DISTRICT OF COLUMBIA
A PLANNED UNIT DEVELOPMENT

MODIFICATION TO A CONSOLIDATED PLANNED UNIT
DEVELOPMENT APPROVED PURSUANT TO ZONING
COMMISSION CASE NO. 07-26

DRAWING INDEX

APPROVED PUD ELEVATION

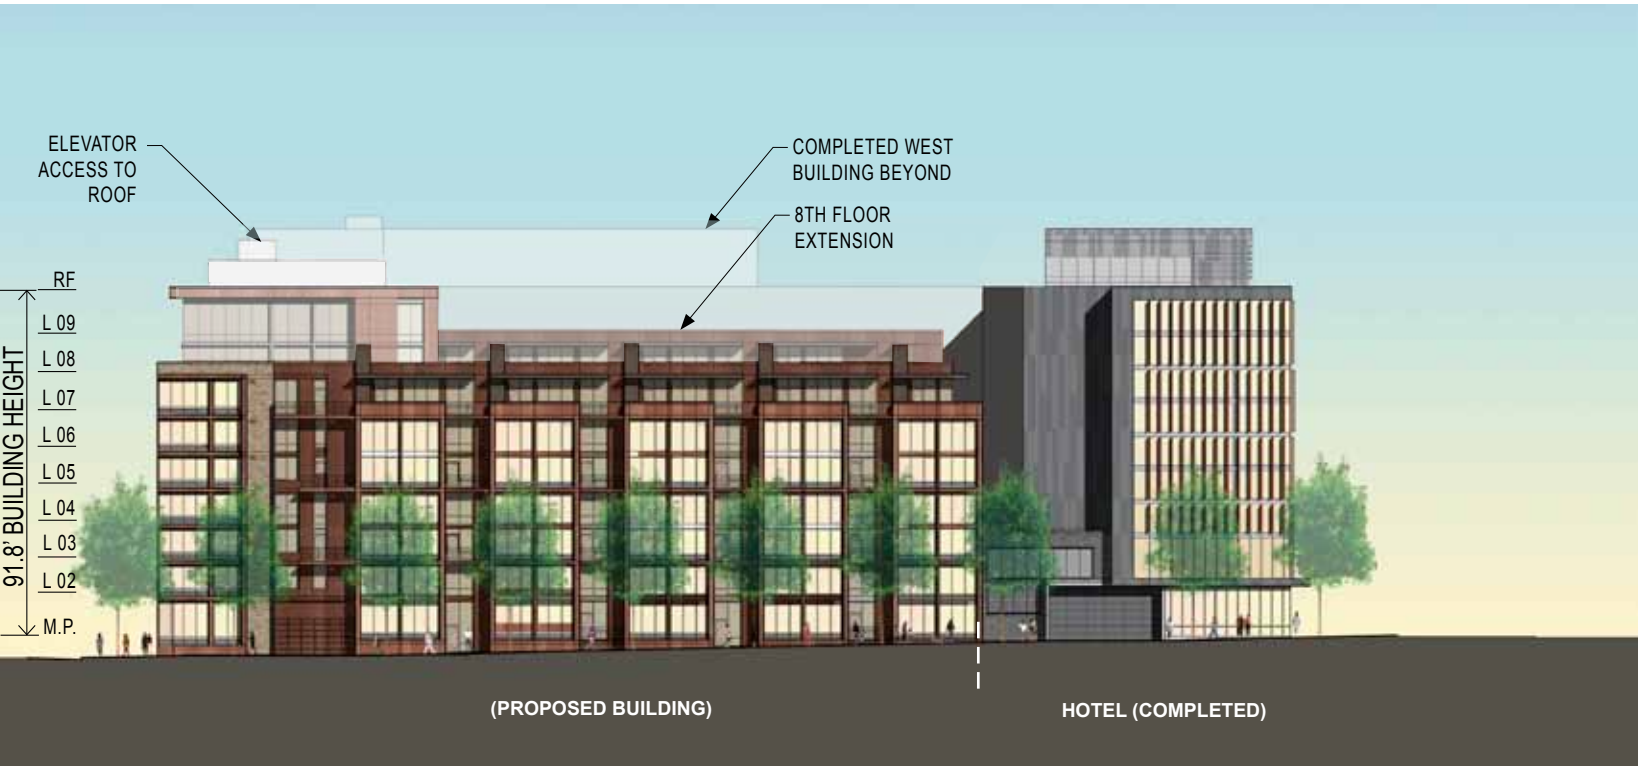
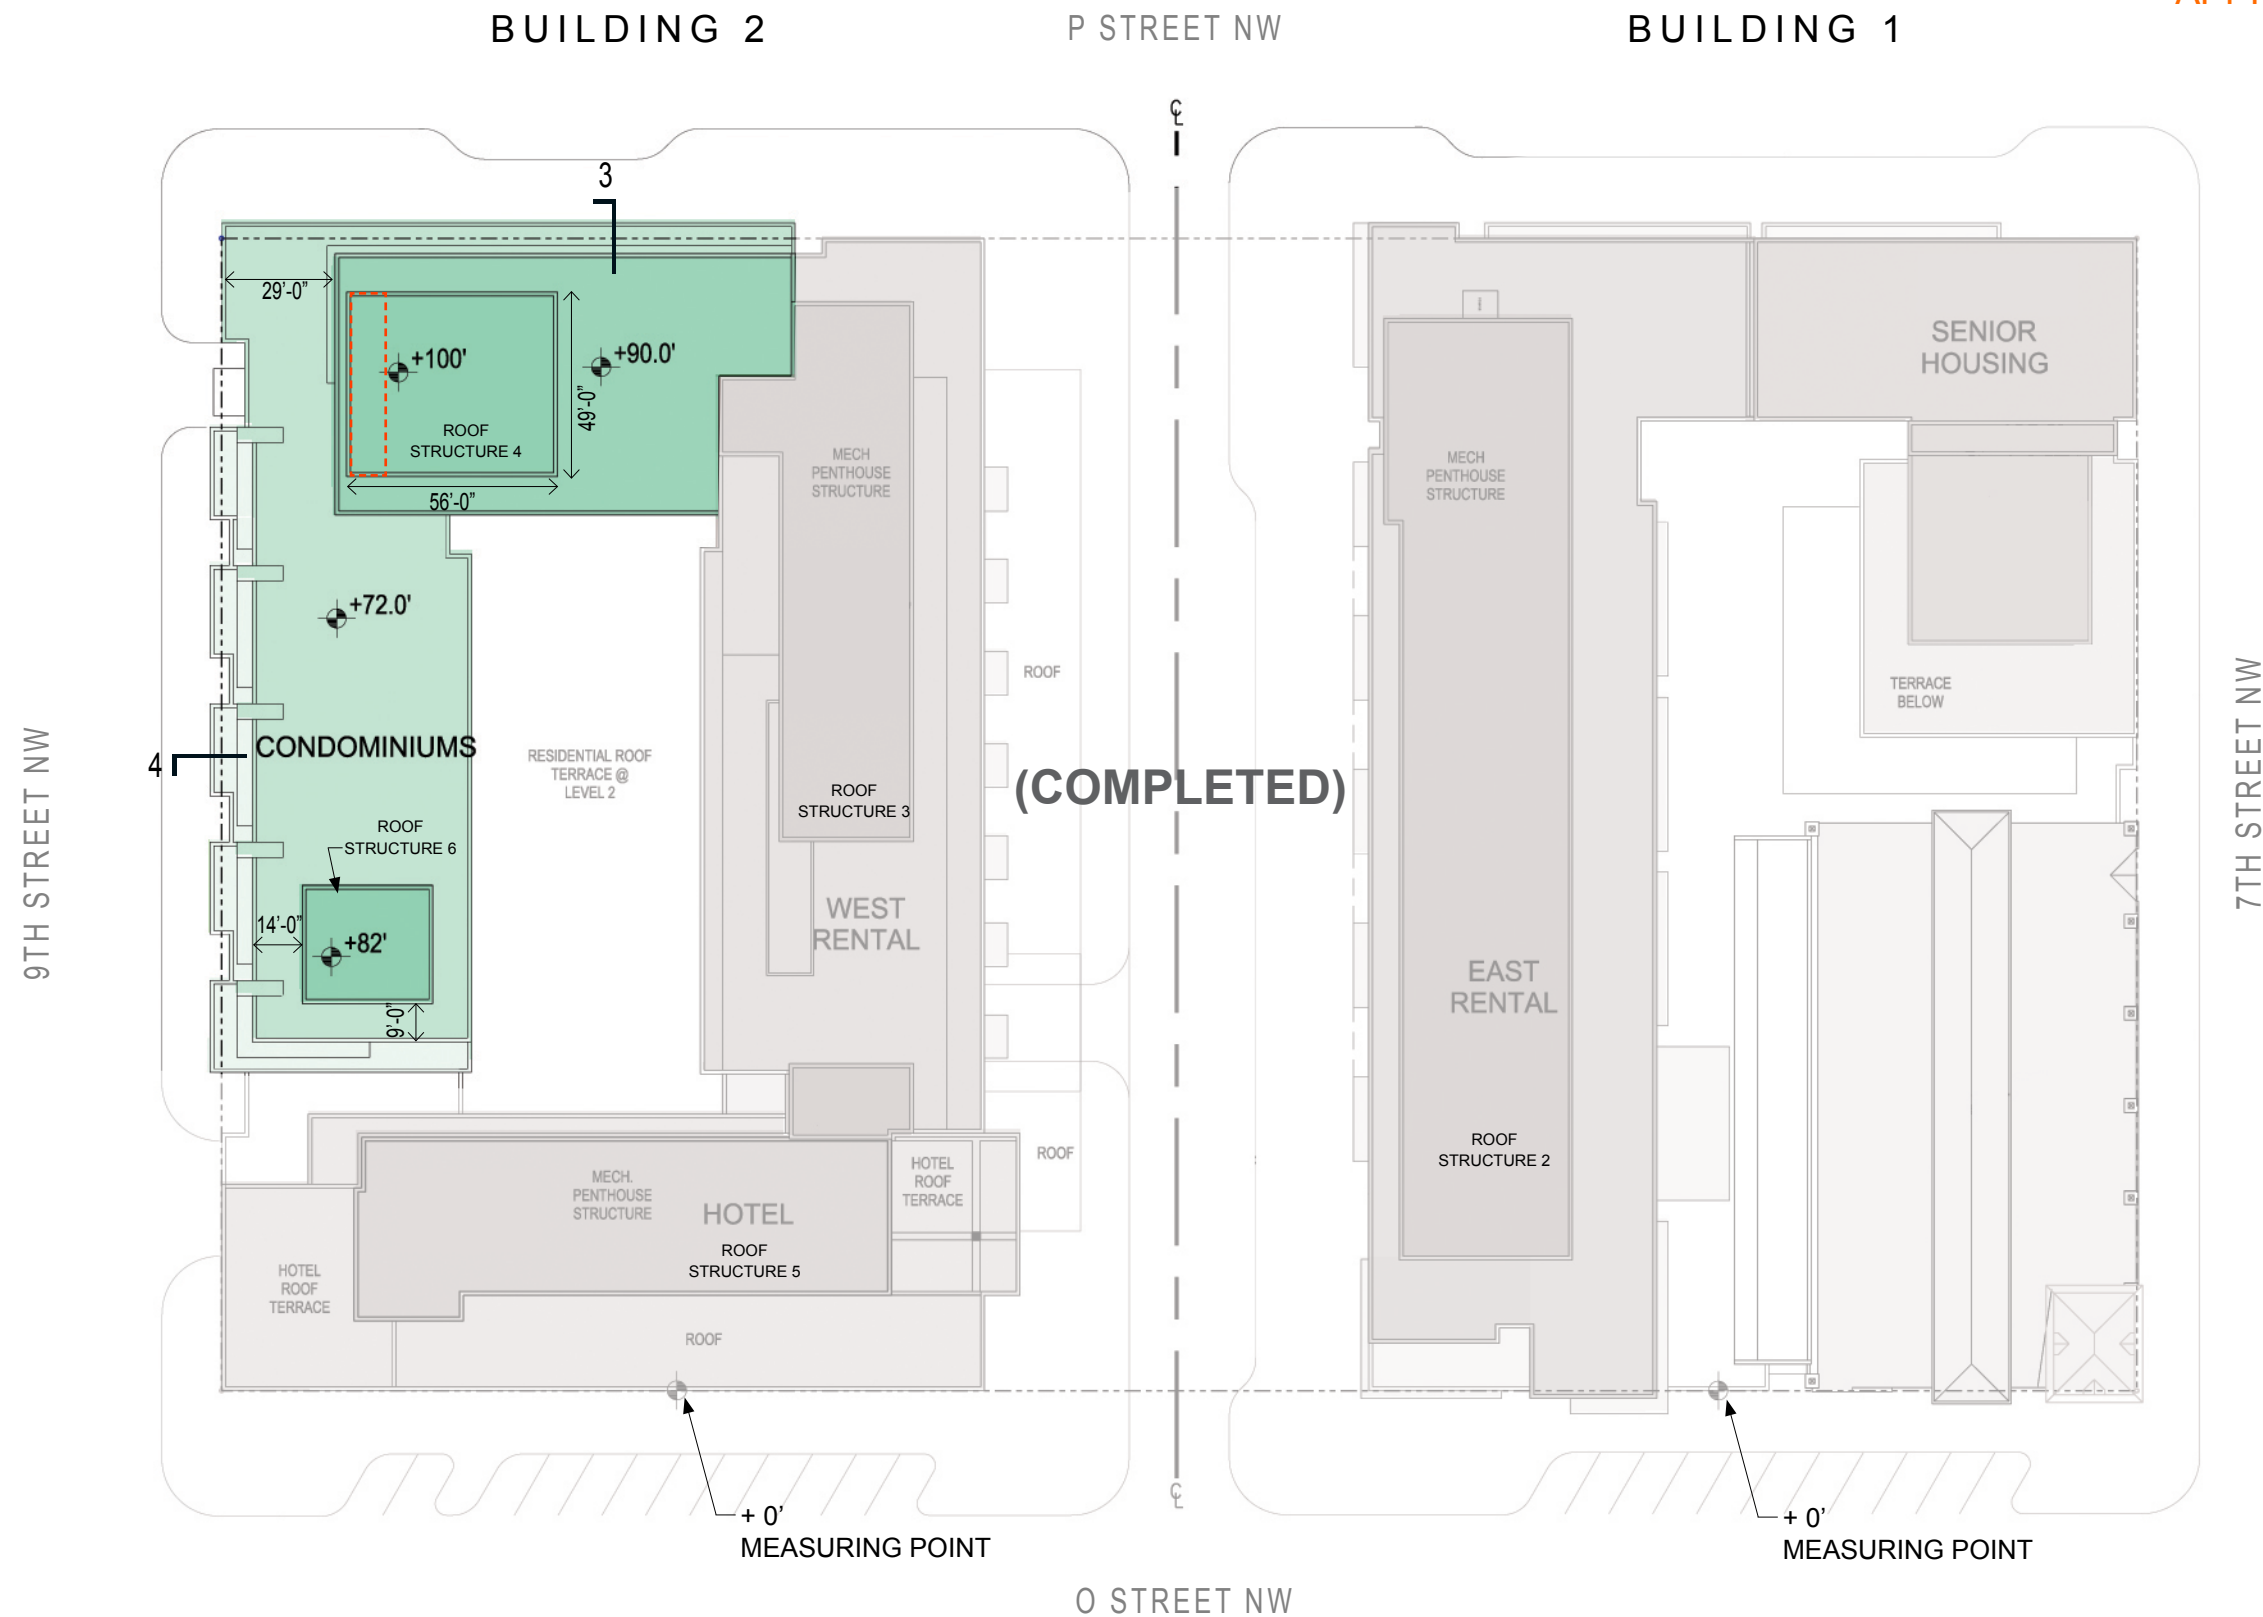
NO ELEVATOR ACCESS TO THE ROOF
IN THE APPROVED ROOF PLAN (SEE
PAGE A.08).

NEW ELEVATOR PROVIDES FOR ADA
ACCESS TO THE ROOF.

APPROVED NON COMPLIANT ROOF STRUCTURE SETBACK

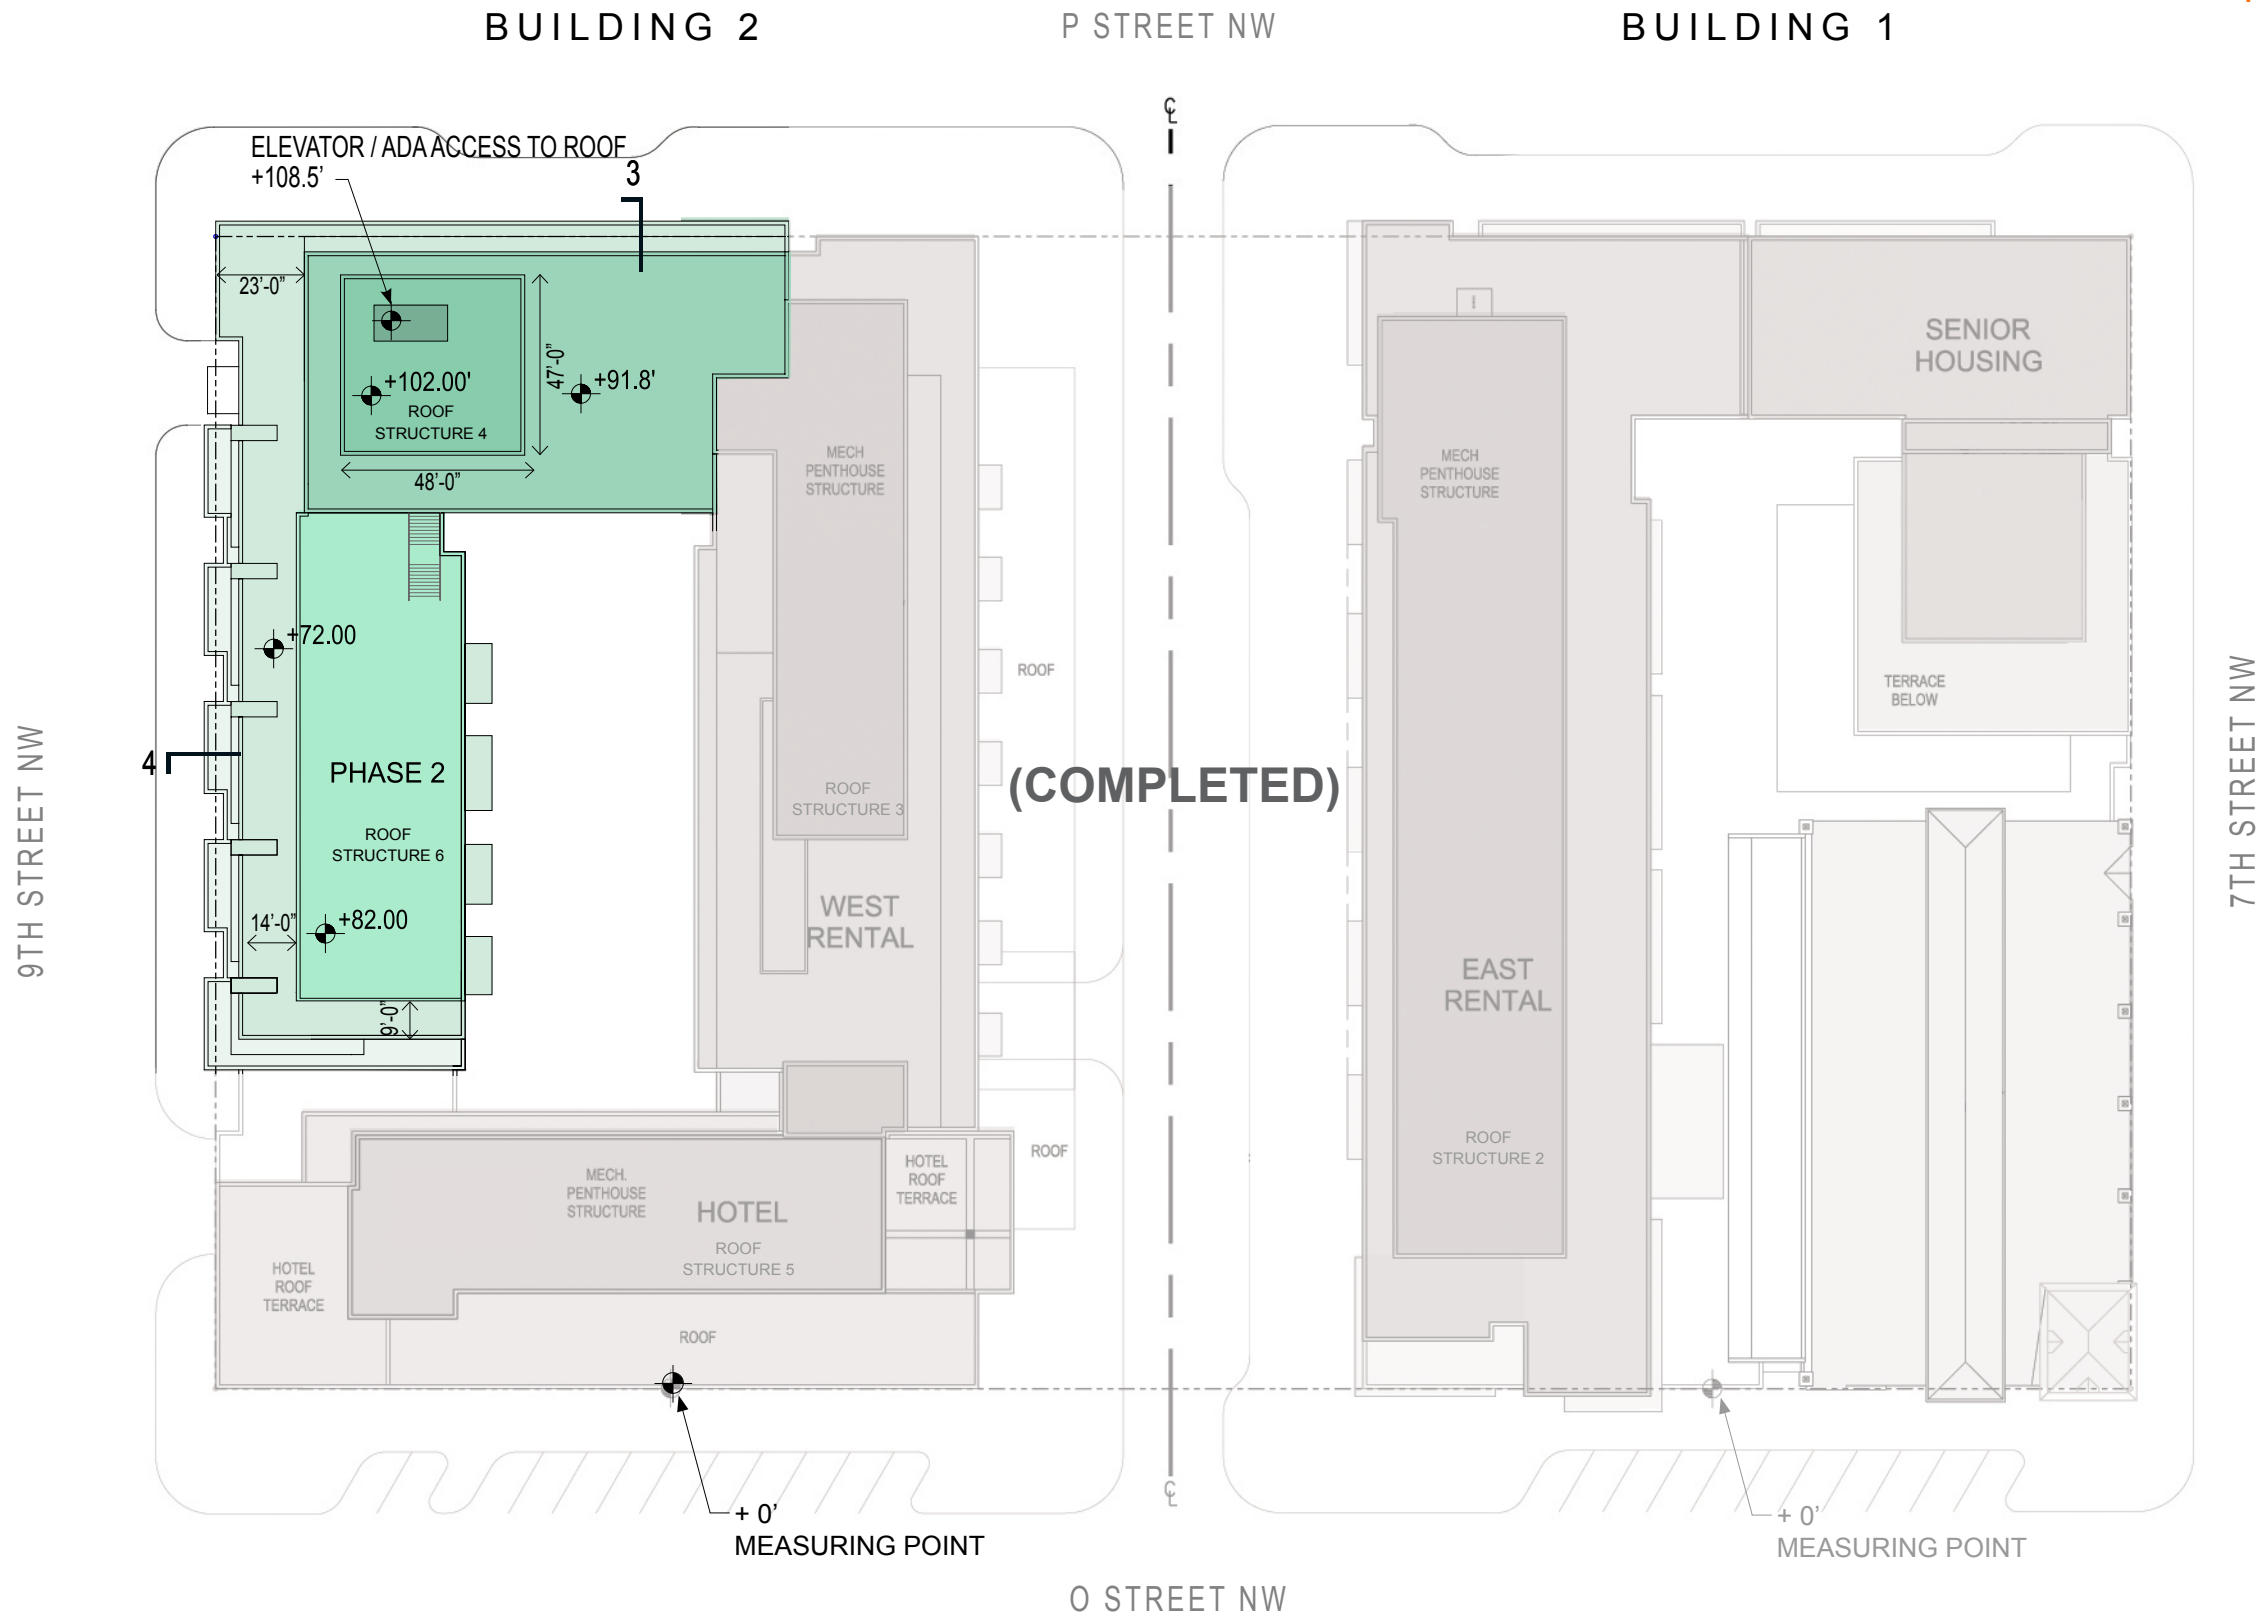
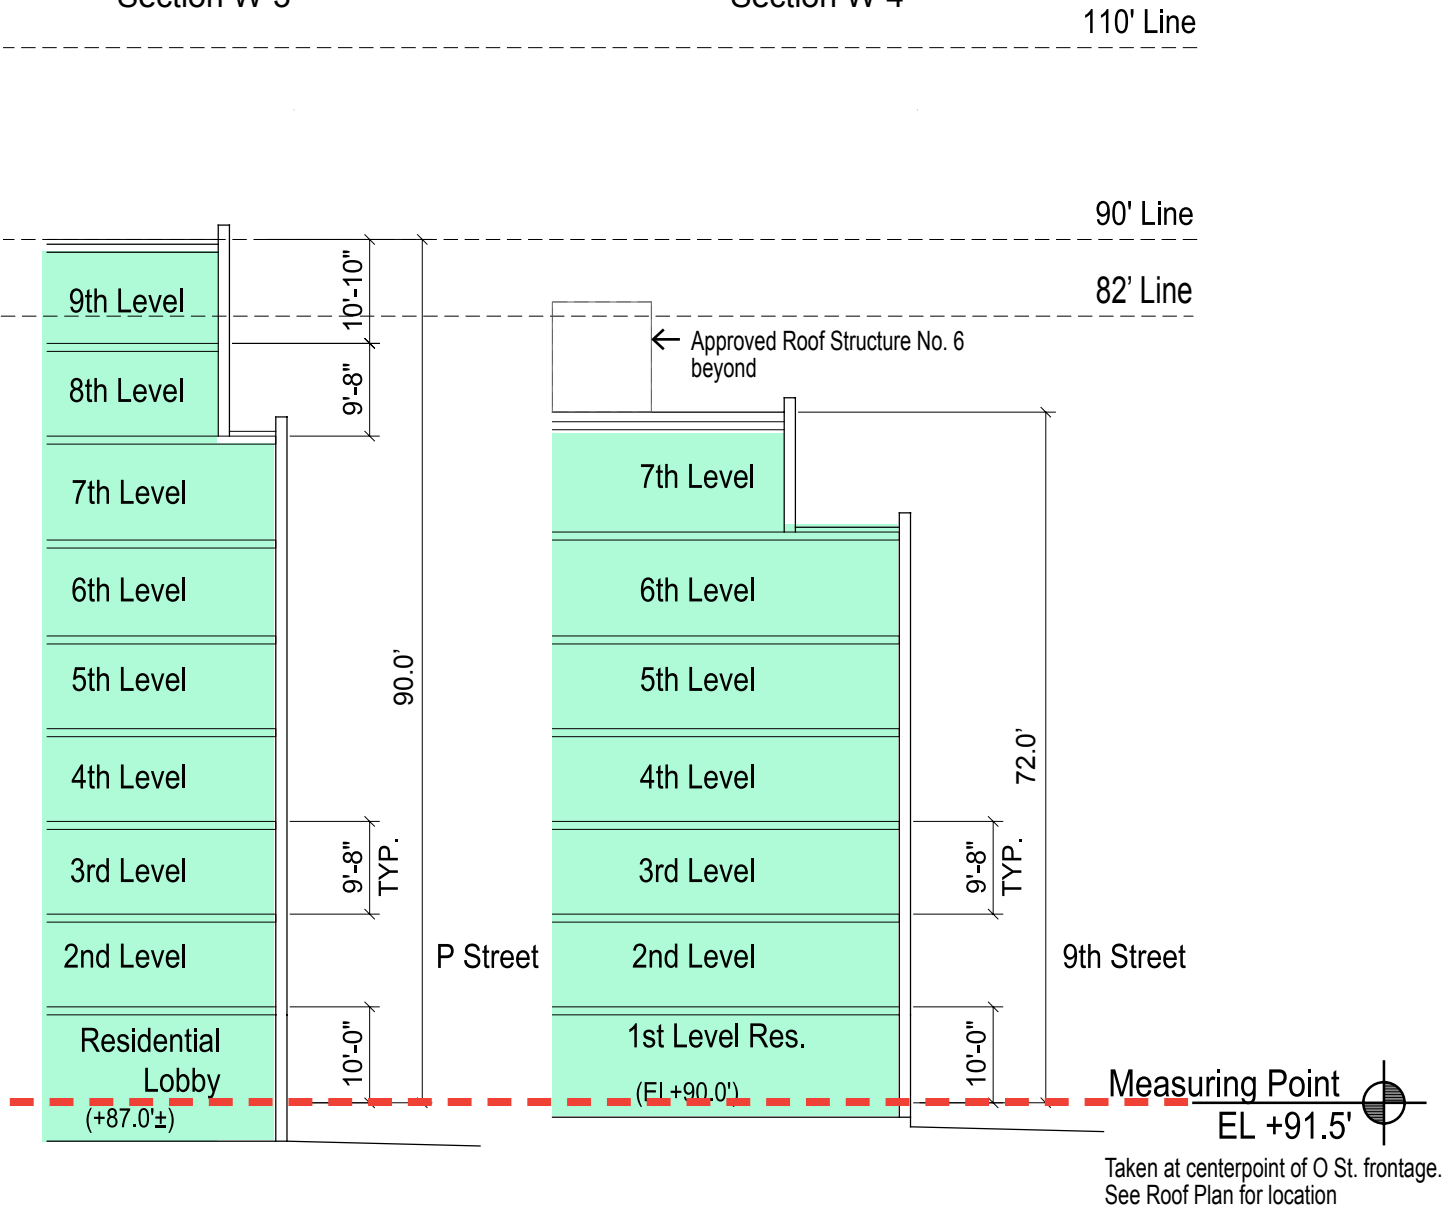
IN RESPONSE TO THE ZONING COMMISSION'S COMMENTS AT THE SETDOWN HEARING OF JUNE 26TH 2014, THE DESIGN OF THE PROPOSED ROOF STRUCTURE 4 AND ELEVATOR CORE LOCATION HAS BEEN MODIFIED TO ALLOW FOR THE 1:1 SETBACK REQUIREMENT TO BE MET. ROOF STRUCTURE 4 AND THE PROPOSED ELEVATOR POP UP HAS BEEN MODIFIED SO THAT THE ENTIRE ROOF STRUCTURE IS NOW COMPLIANT WITH THE 1:1 ZONING SETBACK MAKING THE ROOF STRUCTURE LESS NOTICEABLE FROM PUBLIC VIEW THAN IN THE ORIGINALLY APPROVED PUD. ENABLING THE ELEVATORS, LOCATED AT THE NORTH WEST CORNER OF THE BUILDING TO RUN UP TO THE ROOF WILL ALLOW FOR RESIDENT ACCESS AND THE NECESSARY ADA ACCESSIBILITY TO THE PLANNED ROOFTOP AMENITIES.

NON COMPLIANT ROOF
STRUCTURE SETBACK ELIMINATED
